West Haven Road Safety Audit

Route 705 (Ocean Avenue): Route 162 (Jones Hill Road)
to South Street

Exhibit 31: Concept for the Morris Street intersection and Curve on Route 705 (Ocean Avenue)

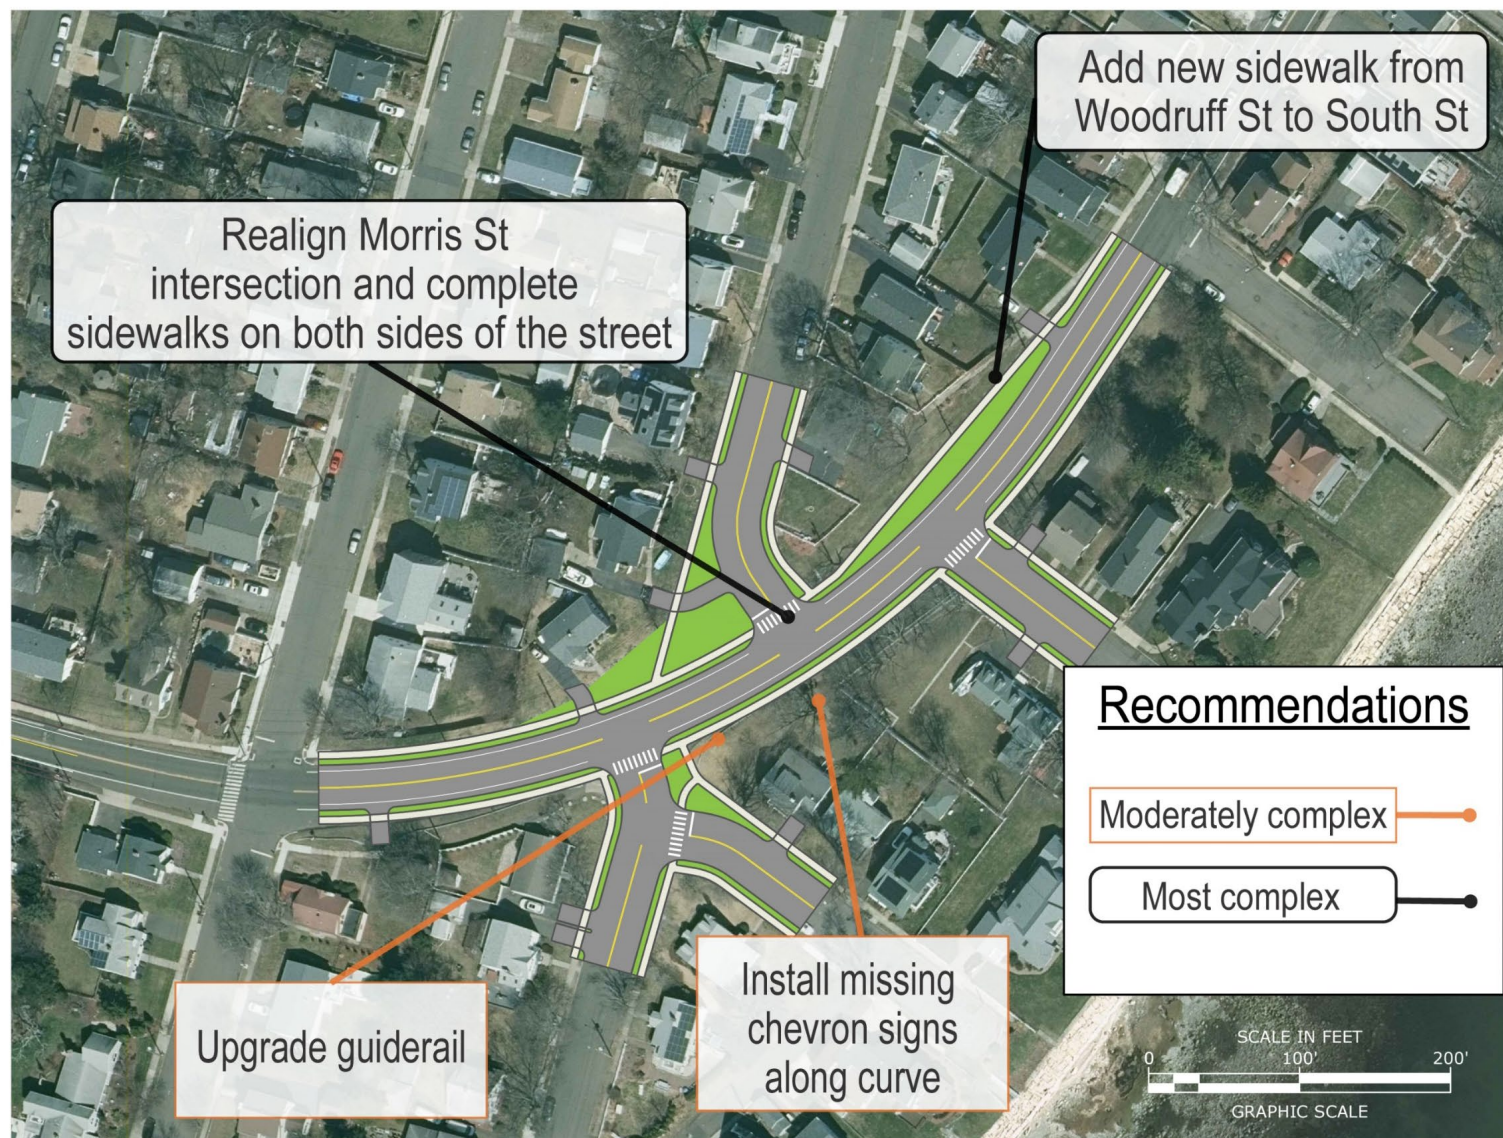
- 3) Realign intersection at Morris Street and complete sidewalks on both sides of the street in this area. Exhibit 3 displays a preliminary concept drawing for this redesign.

- **Next Step:** Municipality to contact [SCRCOG](#) for potential funding sources

- **Next Step:** Municipality to check available ROW and roadside area for feasibility
- **Next Step:** Municipality to coordinate with adjacent property owners for access management
- **Next Step:** Municipality to consider applying for an [Encroachment Permit](#) through the District permit office
